Rezoning Transportation Analysis

Petition Number: 2020-068

General Location Identifier: Tax ID. 17514688

Date	Description
05-18-2020	First Review
06-28-20	Second Review

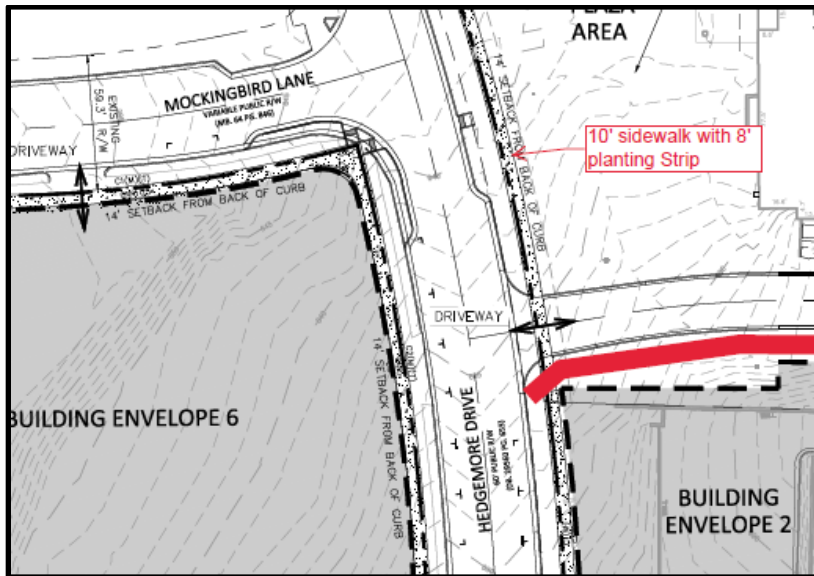
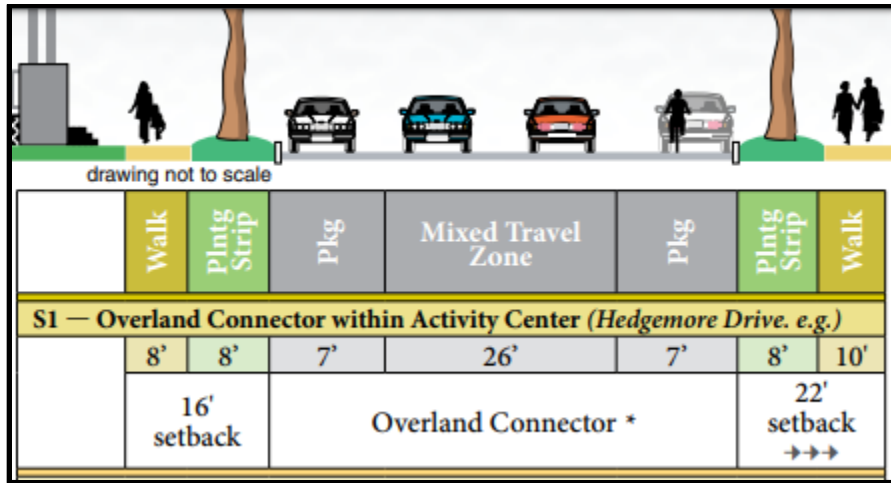
- Traffic Study** A Traffic Impact Study is necessary for the complete review of this petition due to the site generating more than 2500 daily trips.

Staff will receive the petition and begin work on it, but the public hearing will not be scheduled until the TIS is received. This will allow for the minimum time necessary for CDOT to review and approve the study and reach agreement with the petitioner on the required transportation commitments, and have them included on the last site plan submitted no fewer than 4 weeks prior to the public hearing. Therefore, additional traffic mitigation comments may be forthcoming once the TIS is approved by CDOT and NCDOT.

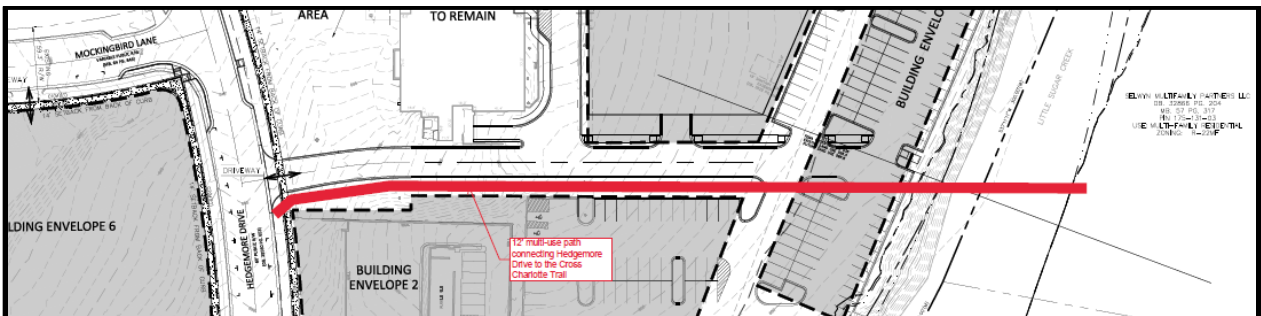
- CDOT requests that the petitioner revise the site plan and conditional note(s) to commit to a 12' multi-use path connecting Hedgemore Drive to the Cross Charlotte Trail (XCLT) including a pedestrian bridge over Little Sugar Creek east of the site, to meet the City of Charlotte BIKE Policy. CDOT also requests a public access easement with parking and a trailhead to the XCLT as a Traffic Demand Management (TDM) measure.

S2 — Other Local Streets within Activity Center						
8'	8'	7'	26'	7'	8'	8'
16' setback		Office/Commercial - Wide			16' setback →→→	
S3 — Local Streets within Wedge Neighborhoods

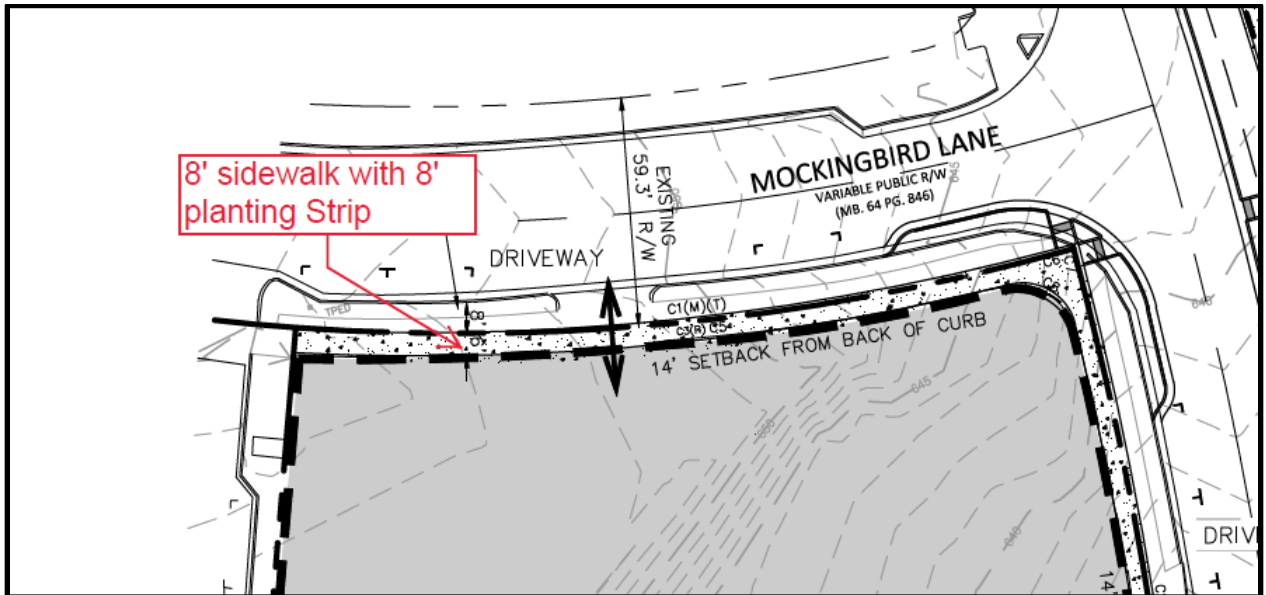
- The petitioner should revise the site plan and conditional note(s) to commit to constructing an 8-foot planting strip, and an 8-foot sidewalk on Mockingbird Lane per the Park Woodlawn Area Plan. The site plan should label and dimension both items from the back of curb and gutter to the road centerline.
